Access Compliance Report

Public Rights-of-Way

(Curb Ramps)

Intersection ID: 47614	Main Street: WYALONG_DR	Cross Street: MACQUARIE_LN	Location: SE
ADA ID: 1F3325F6AB7D	Ramp Type: BlendTrans1	Initial Pass/Fail: Pass	Overall Compliance: No
Severity Score: 5.25			
Codes/Mitigation Info/Possible Solution		Field Measurements/Component Compliance

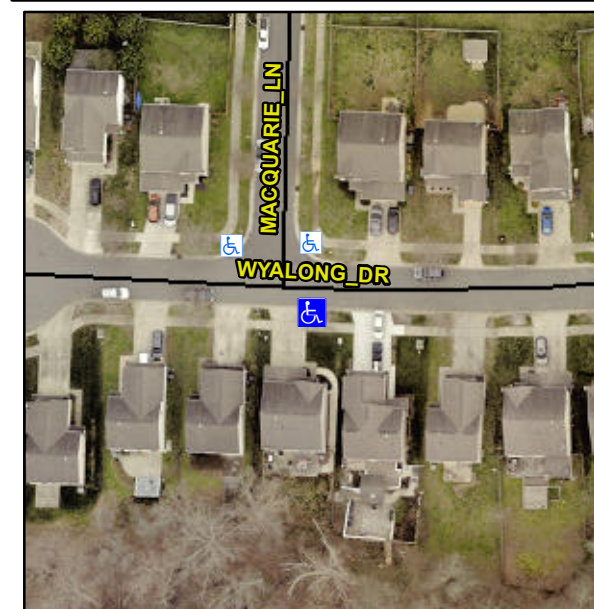
Compliance	Description	Data	Compliance	Description	Data
N/A	Ramp Length (in)	71.0	Yes	BlendTrans Slope (%)	4.6
Yes	Ramp Width (in)	48.0	Yes	BlendTrans XSlope (%)	3.4
N/A	Flare Type LT	Sloped	N/A	Flare Type RT	Sloped
N/A	Flare Slope LT (%)	1.0	Yes	Flare Slope RT (%)	0.5
N/A	Flare Traversable LT?	No	N/A	Flare Traversable RT?	Yes
Yes	Landing Length (in)	60.0	Yes	DWS Provided?	Yes
Yes	Landing Width (in)	48.0	Yes	DWS Contrast?	Yes
No	Landing Slope (%)	2.6	Yes	DWS Length (in)	24.0
Yes	Landing X Slope (%)	3.5	Yes	DWS Full Width?	Yes
N/A	Landing Curb? (Y/N)	No	Yes	DWS Offset (in)	2.0
N/A	Shared Landing?	No			
Yes	Gutter Ponding?	No	No	Gutter Slope (%)	5.6
Yes	Gutter Lip Ht (in)	0.0	Yes	Gutter X Slope (%)	1.9
N/A	Painted X Walk1?	No	N/A	Painted X Walk2?	N/A
	X Walk 1 Direction	To N		X Walk 2 Direction	N/A
	X Walk 1 Width (in)	N/A		X Walk 2 Width (in)	N/A
	X Walk 1 Slope (%)	5.6		X Walk 2 Slope (%)	N/A
	X Walk 1 X Slope (%)	4.0		X Walk 2 X Slope (%)	N/A

N/A	Ramp inside XWalk1?	N/A	N/A	Ramp inside XWalk2?	N/A
	Road Slope (%)	4.0		Clear Space?	Yes
	Road X Slope (%)	5.6	N/A	Clear Space to XWalk (in)	N/A
Yes	Any Obstructions?	No	Yes	Storm Grate/Utility Hazard?	No
	Obstruction Type			Storm Grate/Utility Type	
		N/A			N/A
			Yes	Surface Condition? (G/P)	Good
			No	Curb Slope (%)	7.6

Remove & Replace Curb Ramp With Two New Directional Ramps or Equivalent. Remove & Replace Gutter.
